PLAN REVIEW SHEET

2014-059 Revised

Crosland LLC and Allen Tate

Waiting Pad Detail

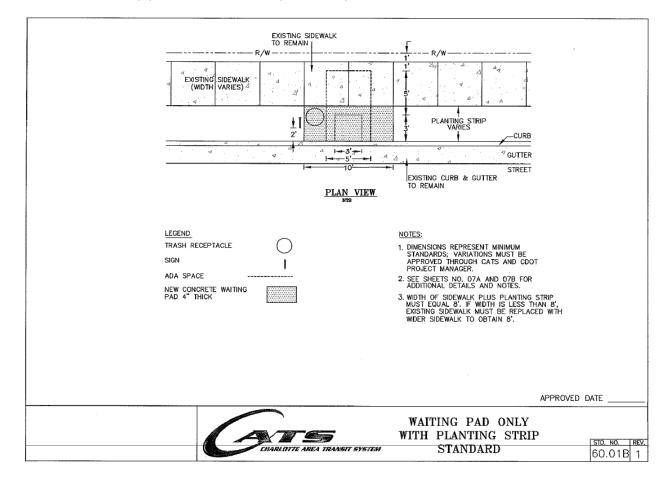
The Petitioner is requested to provide and construct a concrete waiting pad for a relocated bus stop along Sharon Road. In light of the proposed planting strip, the petitioner should use standard detail 60.01B.

Below is an image of the standard detail (60.01B) for the requested bus stop pad. The site plan may either show the conceptual location of the improved bus stop on Sharon Road, or alternatively, include a development note to locate the bus stop pad during the development review and permitting process.
